1 BACKGROUND

In December 2017, Bengalla Mining Company (BMC) lodged MOD4 under Section 96(2) of the *Environmental Planning & Assessment Act 1979* (EPA Act) to Development Consent SSD 5170. MOD4 was accompanied by a Statement of Environmental Effects (SEE) which generally seeks approval for:

BMC commissioned Todoroski Air Sciences (TAS) to undertake revised modelling to respond to DPE’s correspondence of 19 June 2018. This has culminated in a report titled ‘*Air Quality Impact Assessment Bengalla Modification 4 Additional Modelling 12 November 2018*’ (TAS, 2018).

Section 2 of this letter report provides suggested changes to Tables 1 to 3 of SSD 5170 utilising the results of TAS, 2018 (additions are shown in red and deletions in ~~striketrough~~). **Section 3** includes a justification for the suggested changes, whilst **Appendix A** lists references.

Figure 1
 Revised Air Quality Contours (Internal)

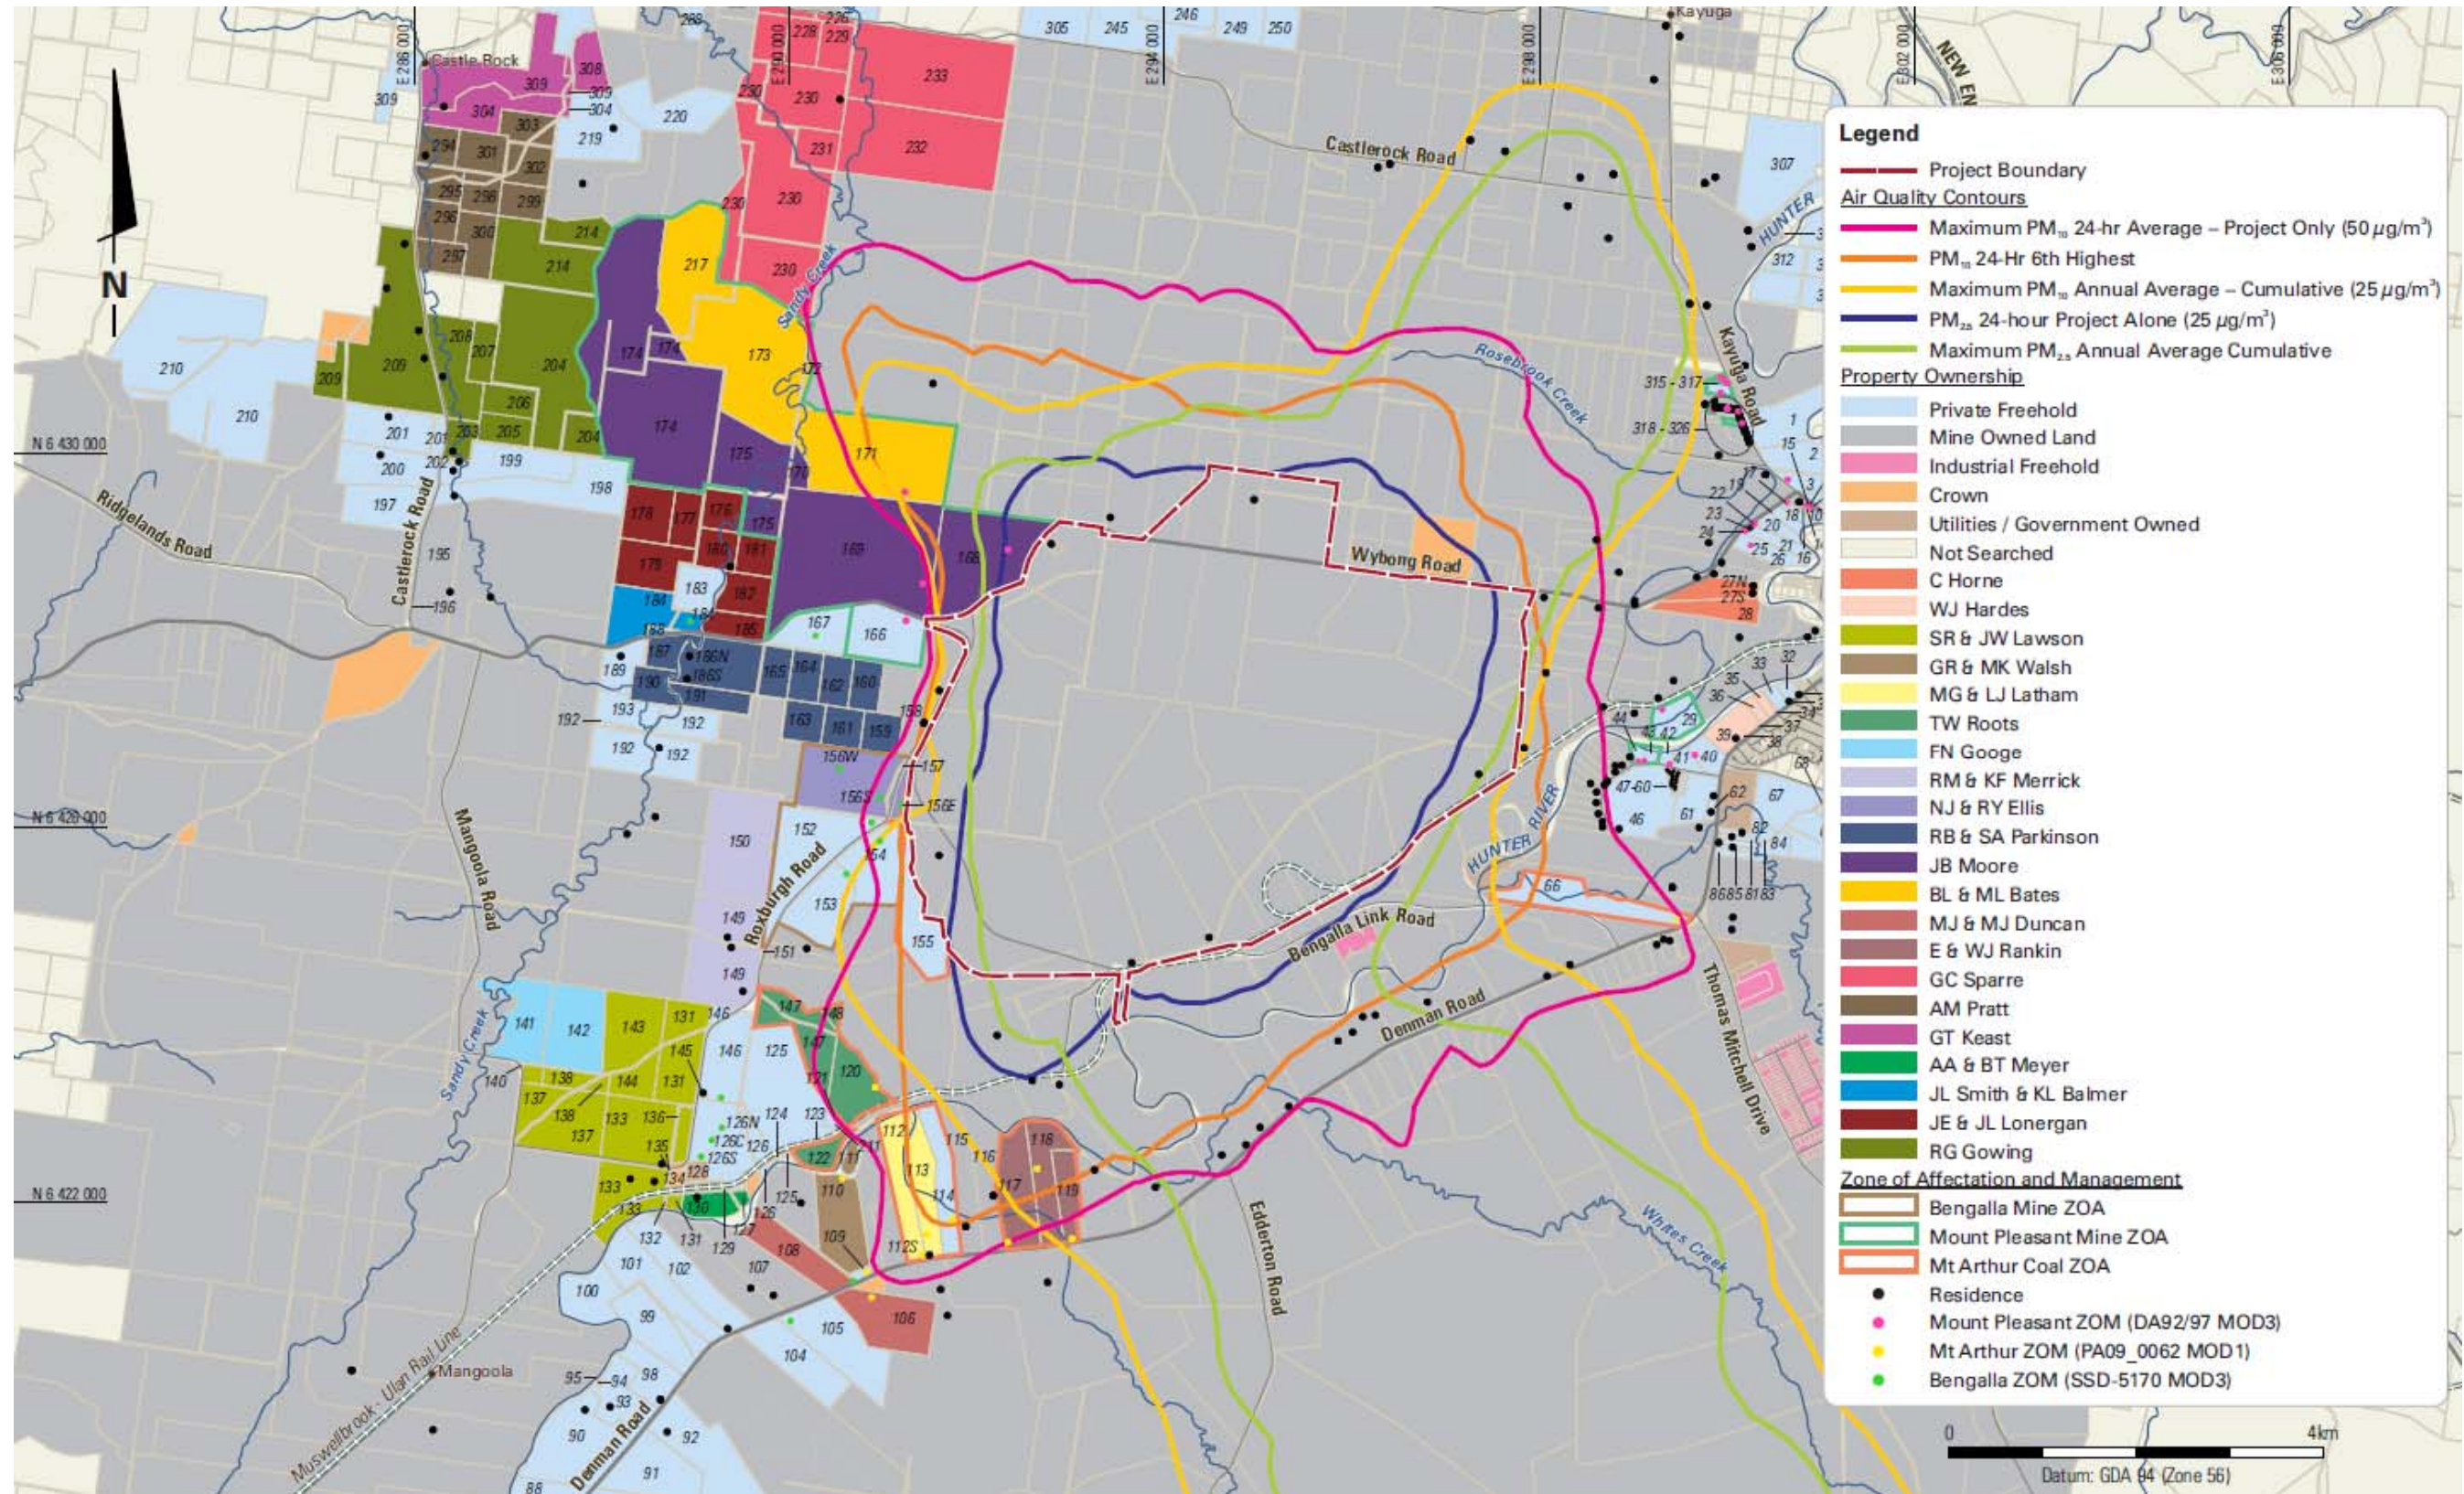
Figure 1 shows key air quality prediction contours from (TAS, 2018) for key air quality parameters (PM₁₀ and PM_{2.5}). It indicates where receivers or blocks of land occur within an existing Zone of Acquisition (ZOA) or Zone of Management (ZOM) for each of Mt Pleasant Mine (MTP), Mt Arthur Coal (MAC) or BMC, as well as indicating contiguous blocks of private property held in single landownership.

As can be seen from **Figure 1**, the greatest air quality impacts are derived from:

- Cumulative PM₁₀ 24 hr project alone (or “incremental”) shown in magenta (ZOM);
- PM₁₀ 24 hr project alone 6th highest (ZOM) shown in orange; or
- PM₁₀ Annual Average Cumulative (or “total impact”) shown in yellow (ZOA).
